METROPOLITAN EDISON COMPANY  
JERSEY CENTRAL POWER & LIGHT COMPANY  
PENNSYLVANIA ELECTRIC COMPANY  
GPU NUCLEAR, INC.  
DOCKET NO. 50-289  
THREE MILE ISLAND NUCLEAR STATION, UNIT NO. 1  
AMENDMENT TO FACILITY OPERATING LICENSE

Amendment No.208  
License No. DPR-50

ATTACHMENT TO LICENSE AMENDMENT NO. 208

**Figure 3.1.1**  
**Reactor Coolant System Combined Heatup/Cooldown Limitations**  
**[Applicable through 17.7 EFPY]**

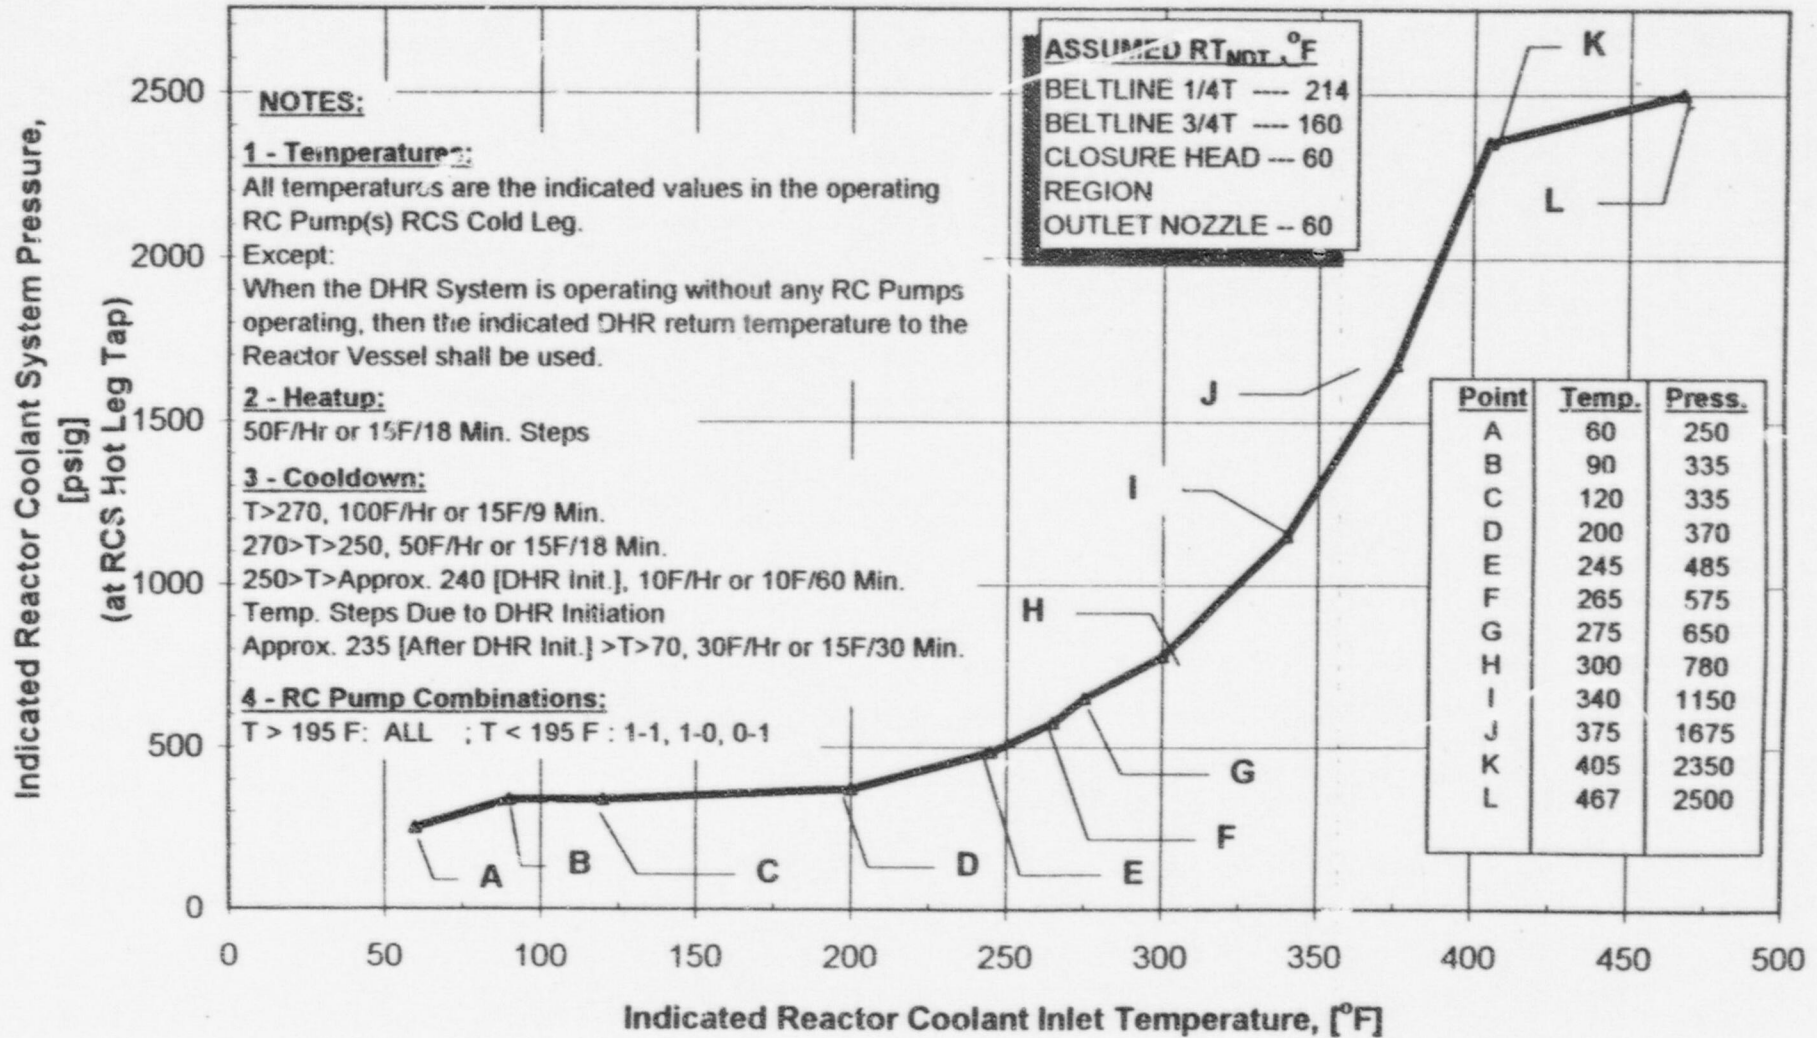
- 3.1.2.1 For operations until 17.7 effective full power years, the reactor coolant pressure and the system heatup and cooldown rates (with the exception of the pressurizer) shall be limited in accordance with Figure 3.1-1 and Figure 3.1-2 and are as follows:

Allowable combinations of pressure and temperature shall be to the right of and below the limit line in Figure 3.1-1. Heatup and cooldown rates shall not exceed those shown on Figure 3.1-1.

- 3.1.2.4 Prior to exceeding 17.7 effective full power years of operation, Figures 3.1-1 and 3.1-2 shall be updated for the next service period in accordance with 10 CFR 50, Appendix G, Section V.B. The highest predicted adjusted reference temperature of all the beltline materials shall be used to determine the adjusted reference temperature at the end of the service period. The basis for this prediction shall be submitted for NRC staff review in accordance with Specification 3.1.2.5.

Based on the predicted  $RT_{NDT}$  after 17.7 effective full power years of operation, the pressure/temperature limits of Figure 3.1-1 and 3.1-2 have been established by FTI calculation, reference No. 7, in accordance with the requirements of 10 CFR 50, Appendix G. Also, see Reference 4. The methods and criteria employed to establish the operating pressure and temperature limits are as described in BAW-10046A, Rev. 2. The protection against nonductile failure is provided by maintaining the coolant pressure below the upper limits of these pressure temperature limit curves.

The pressure limit lines on Figure 3.1-1 and 3.1-2 have been established considering the following:

- a. A 25 psi error in measured pressure.
- b. A 12°F error in measured temperature.
- c. System pressure is measured in either loop.
- d. Maximum differential pressure between the point of system pressure measurement and the limiting reactor vessel region for the allowable operating pump combinations.
